Lead Local Flood Authority Planning Application Response

Lead SCC Officer	Caroline Parkin
Local Planning Authority	Staffordshire Moorlands District Council (SMDC)
Planning application name	Erection of 12 no. Bungalows. Land at Bridge End, Macclesfield Road, Leek.
Planning application reference	SMD/2021/0113
Type of application	Full
Date consulted	27/04/2023
Date of response	17/05/2023

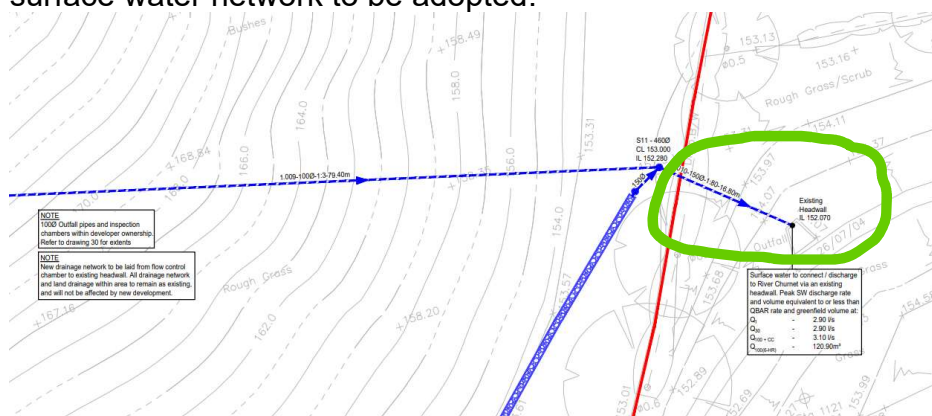
Previous communication has indicated that a new pipe will convey the surface water from the site. From the drainage layout plans provided, the lower extent of the pipe between manhole S11 and the existing headwall will cross through third-party land (circled green below). Please confirm whether permission has been obtained for this part of the network and who will be responsible for future maintenance of this section of pipe should there be any issues in the future. Please also confirm whether it is proposed for any part of the surface water network to be adopted.

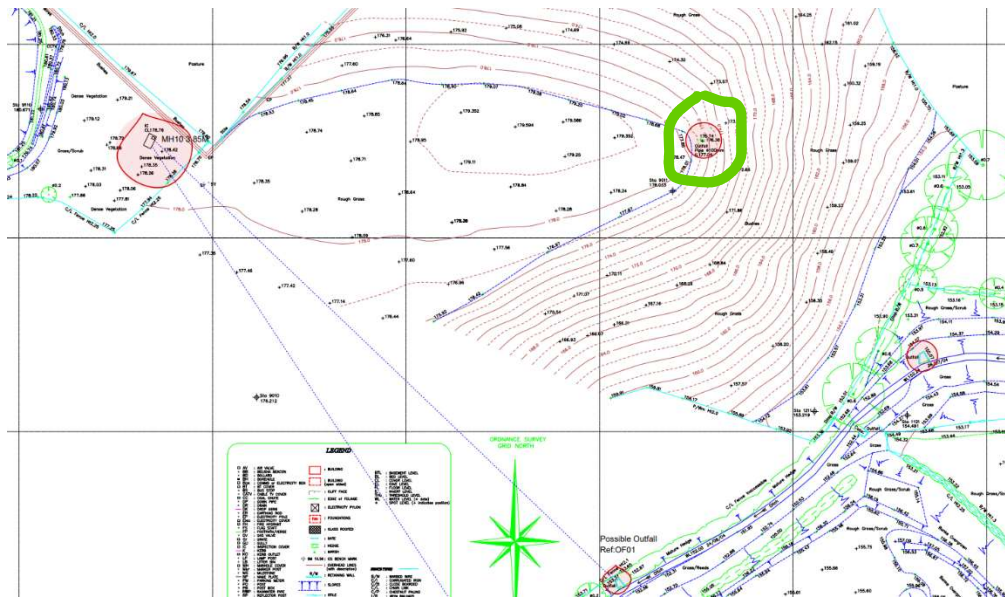
From the plans provided, it would appear that the trench is located outside of both the development and ownership boundary, particularly within the north-western extent of the site at the access road into the site. Please confirm who will be responsible for the management and ownership of this element of the proposals.
